**Application for Revision to Approved Plans**

Project Address: 10 Hobby Lane, Bedford, NY

Revised Rear Deck and outside kitchen & Roof Added over outside kitchen.

Revised Deck and outside Kitchen with New Roof  
Added. No Footprint Change.

FIRST FLOOR REFLECTED  
 CEILING & ELECTRICAL PLAN

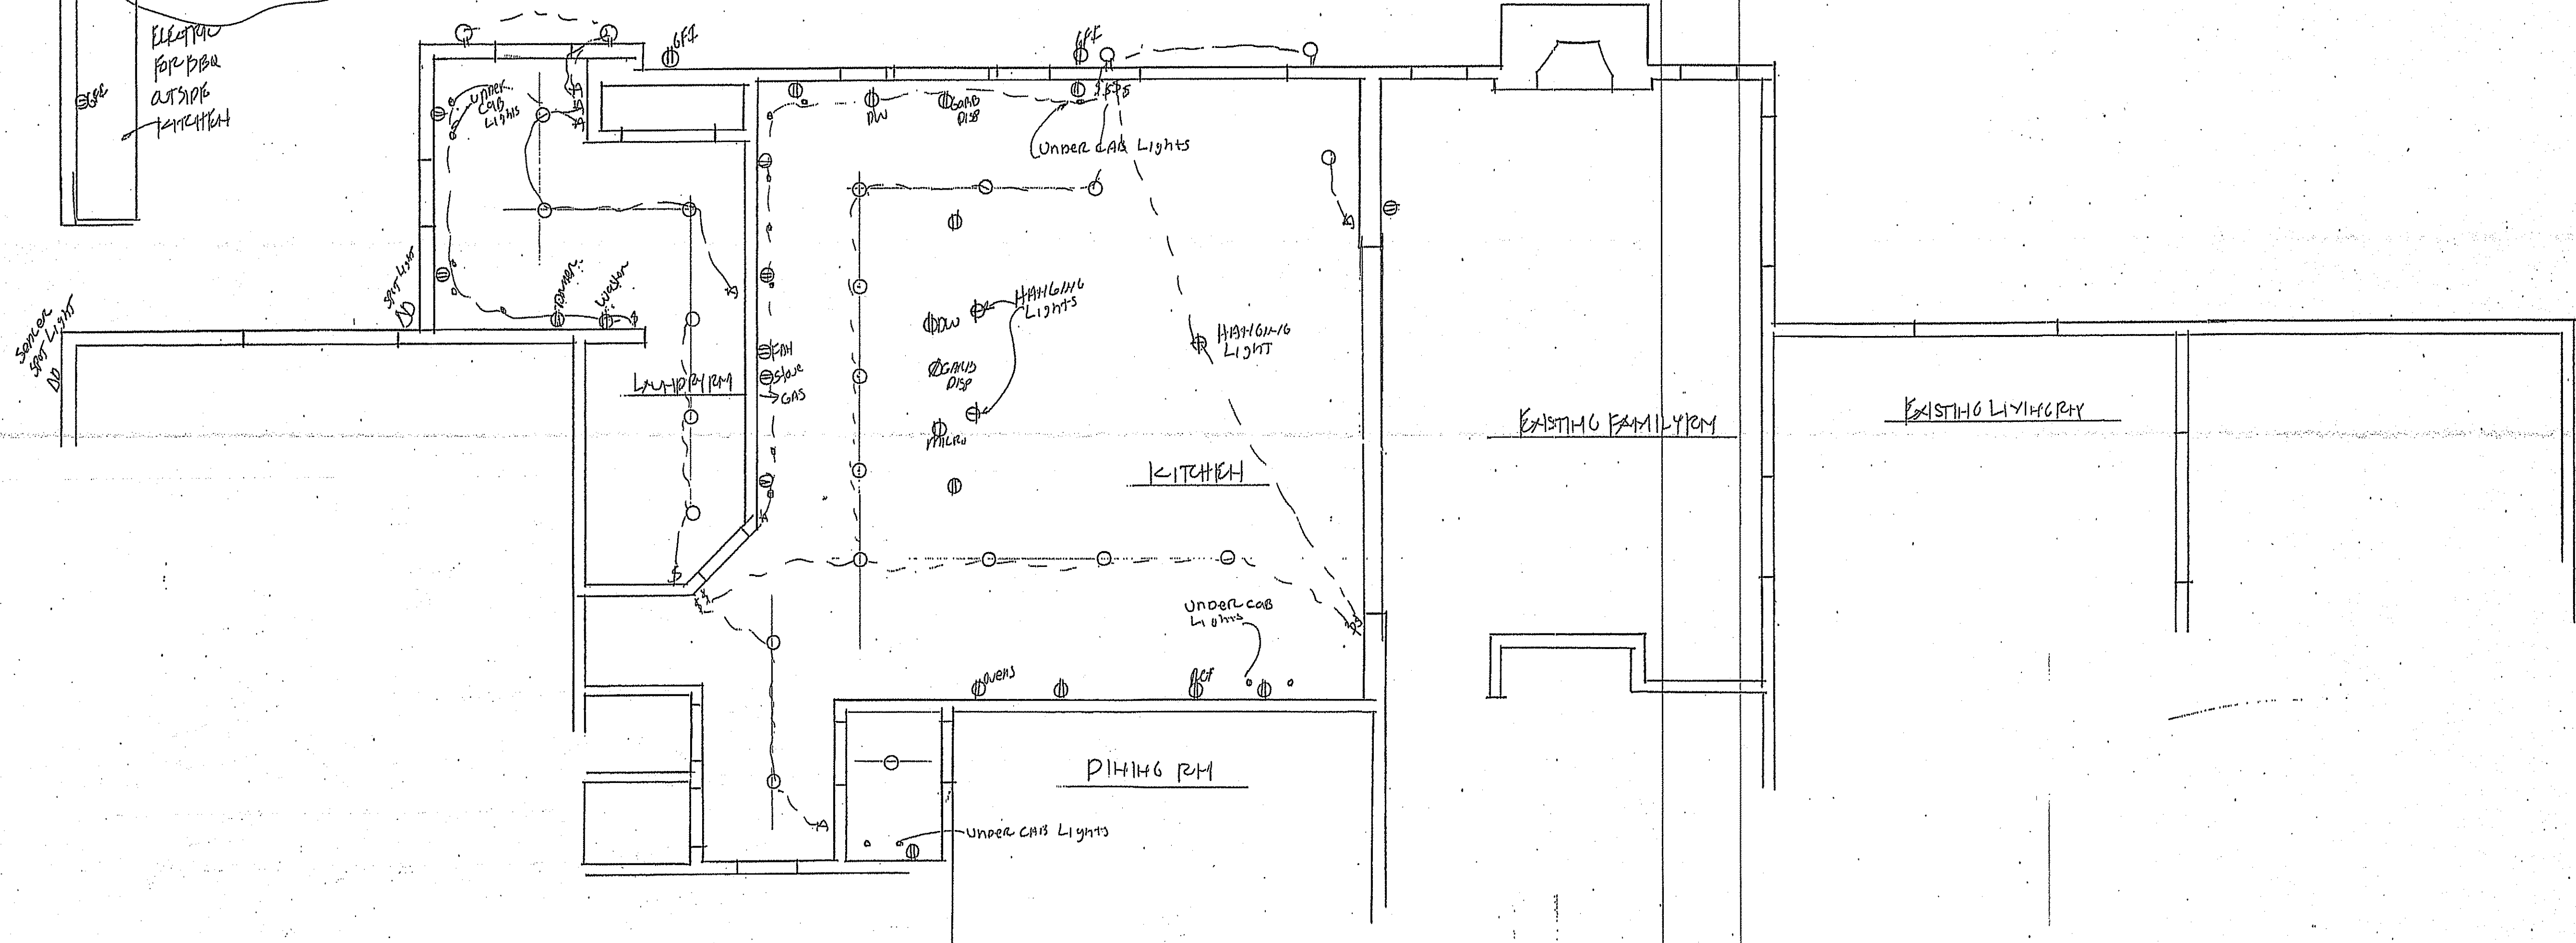
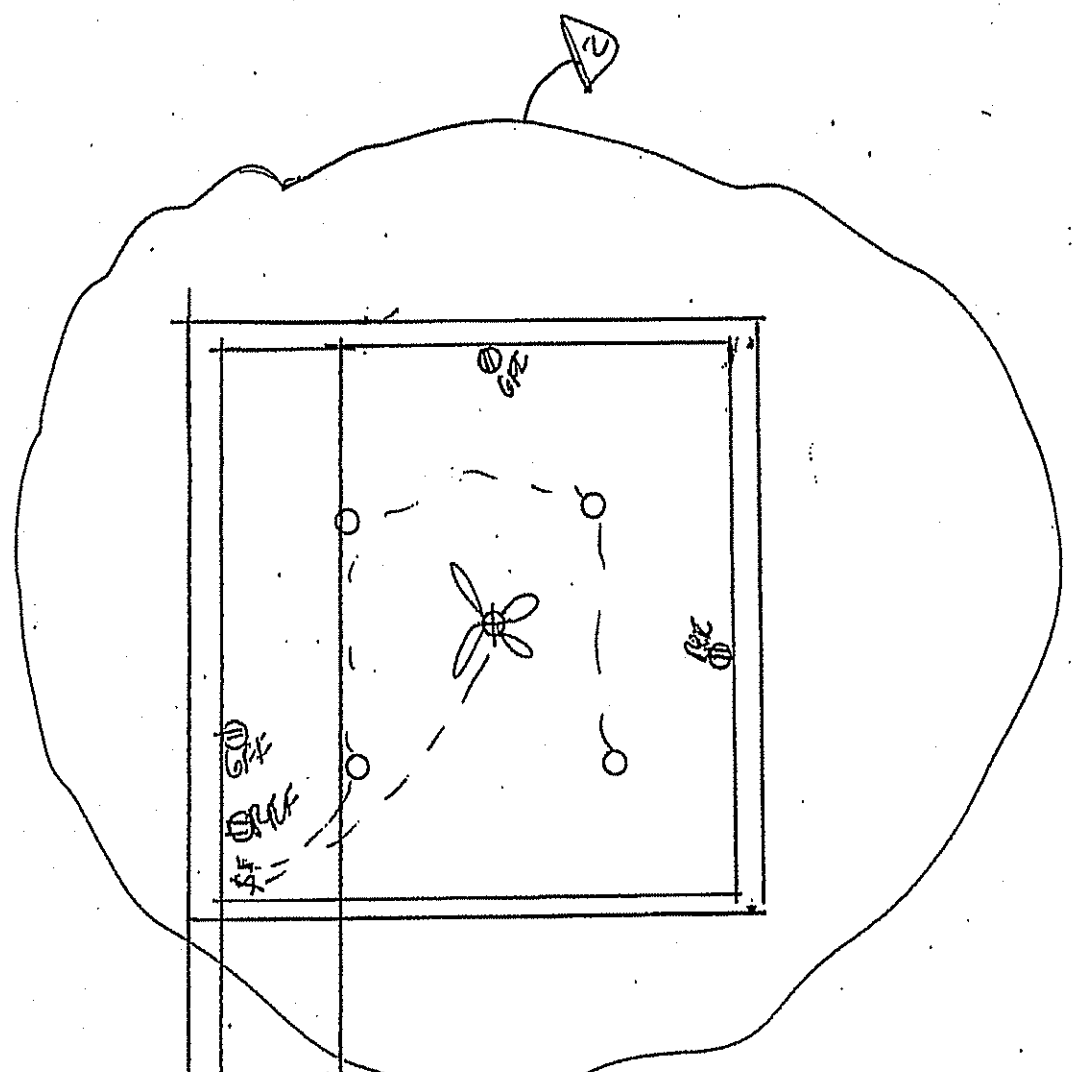
2 Revison Deck and Roof over outside kitchen 8/15/20

FIRST FLOOR PARTIAL DEMOLITION  
 PLAN

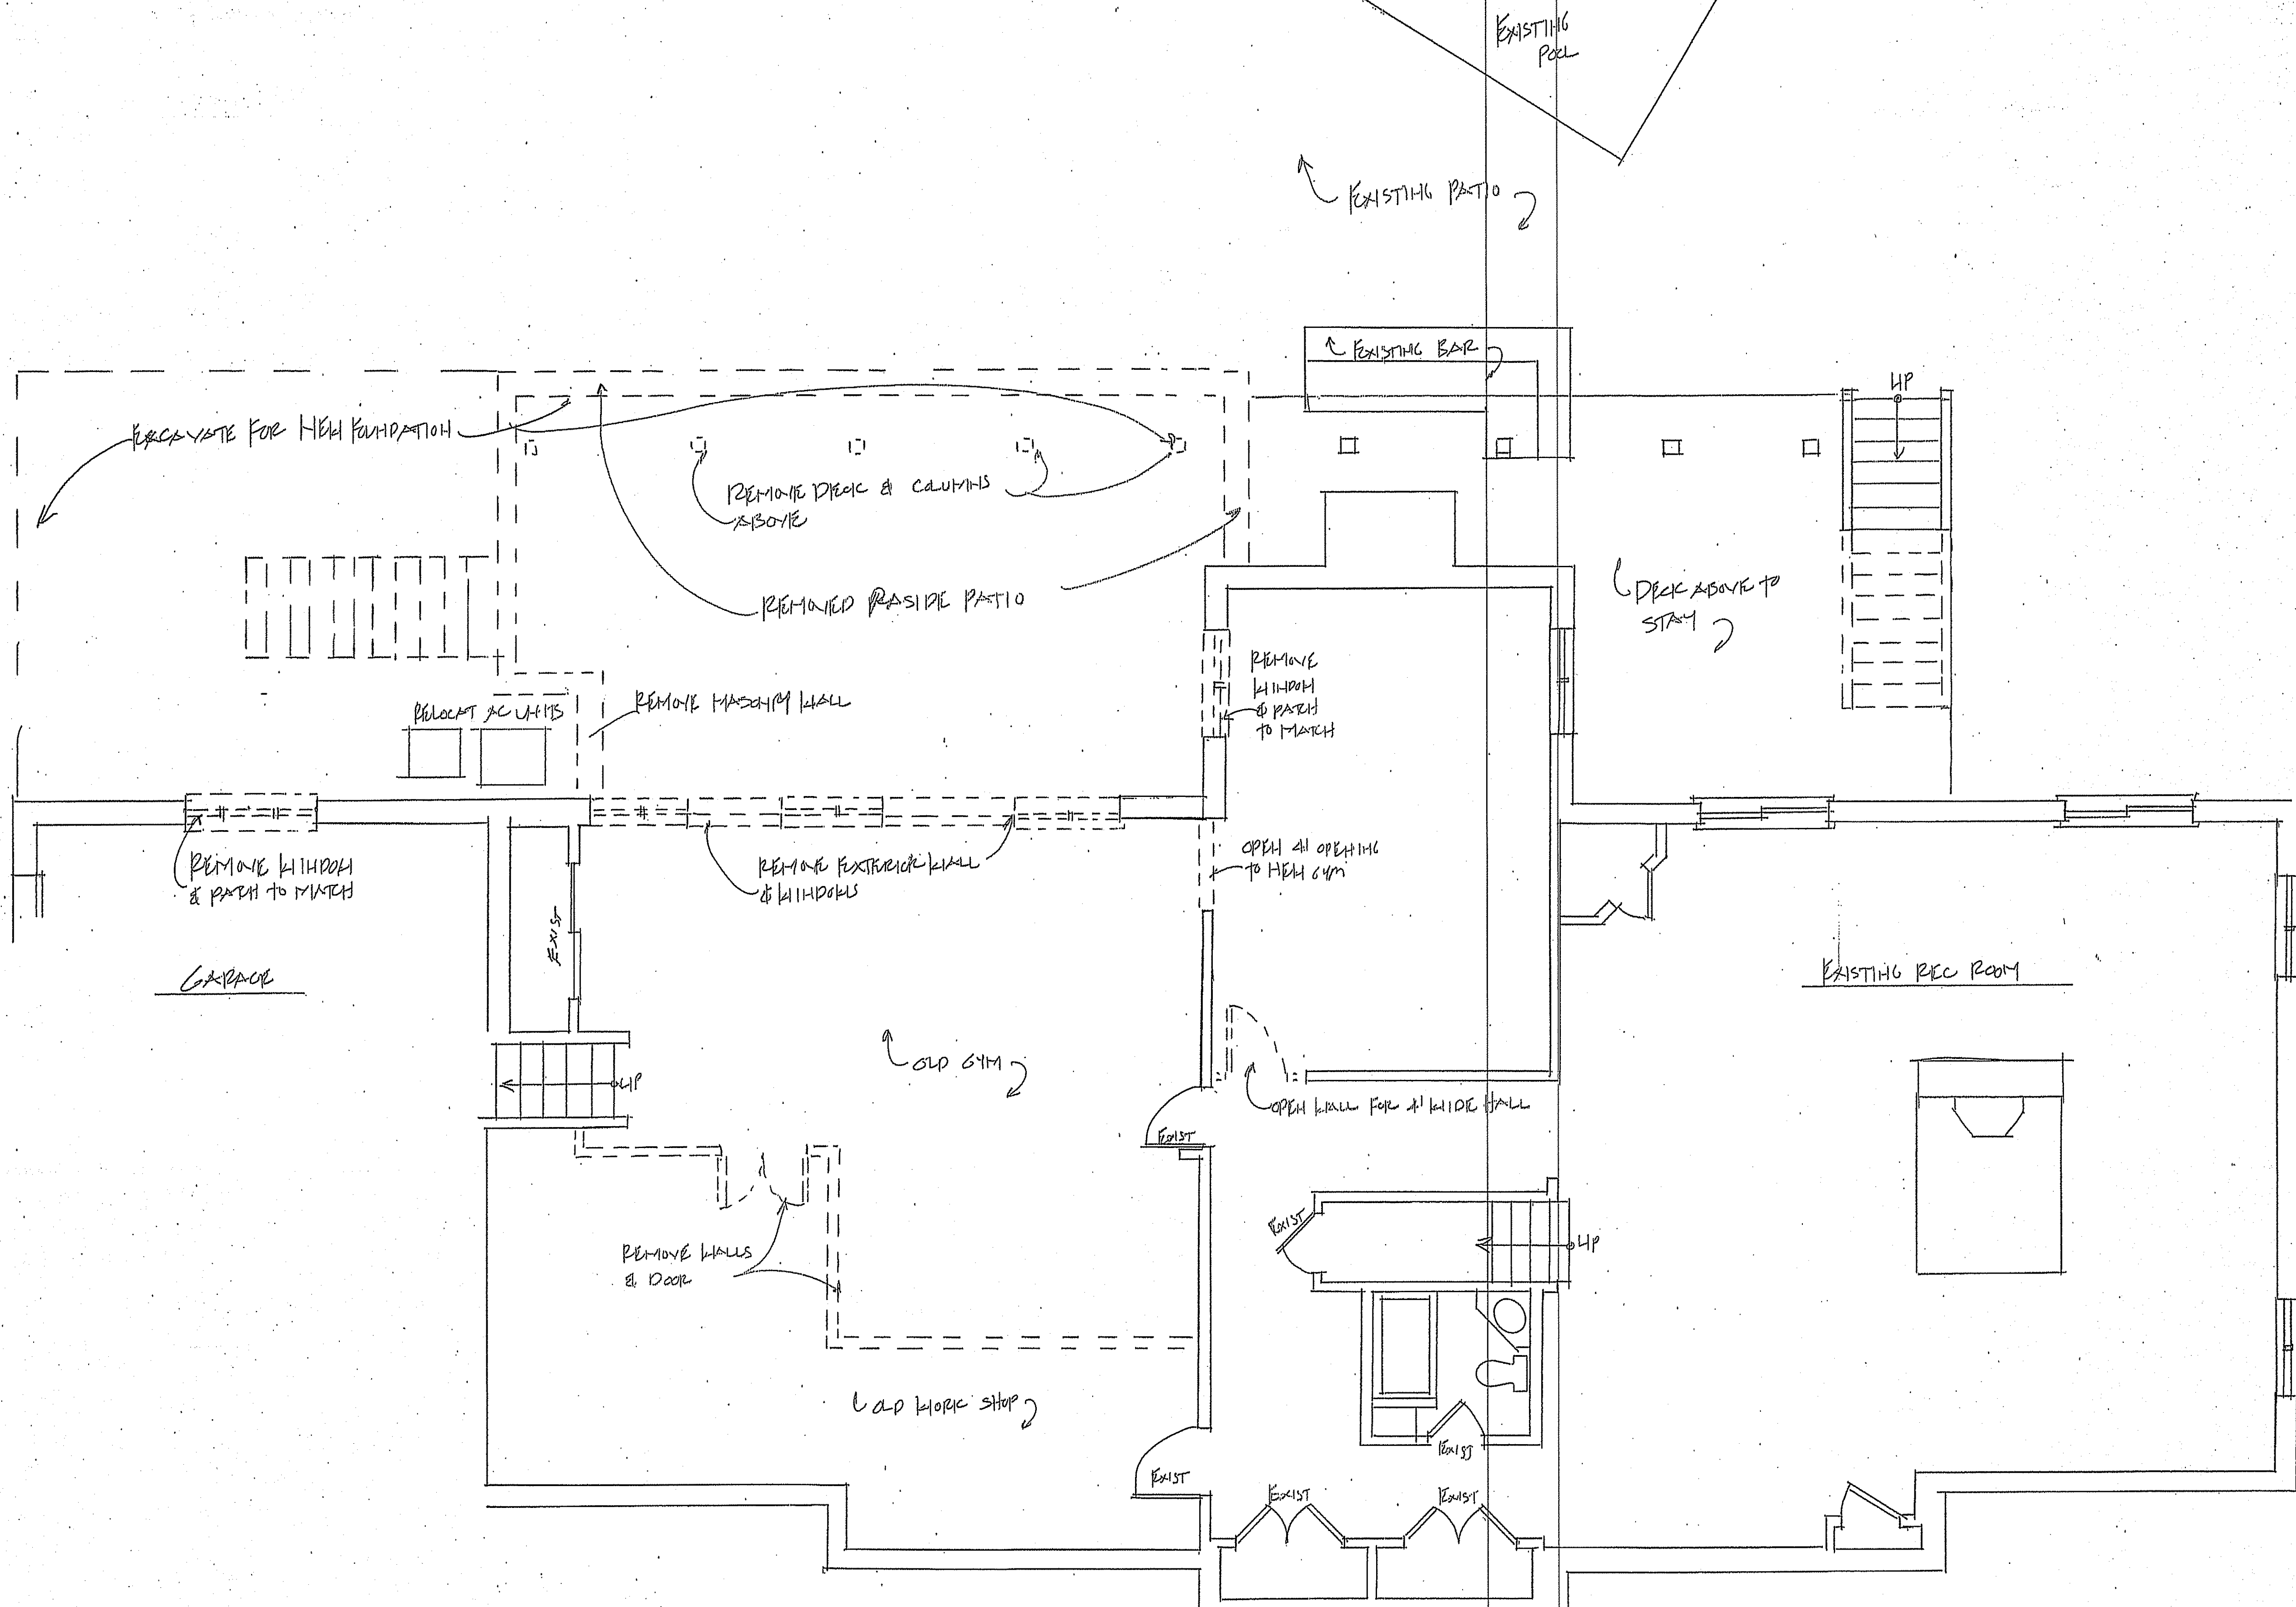
2 Revised Deck and Roof over outside Kitchen 8/15/20
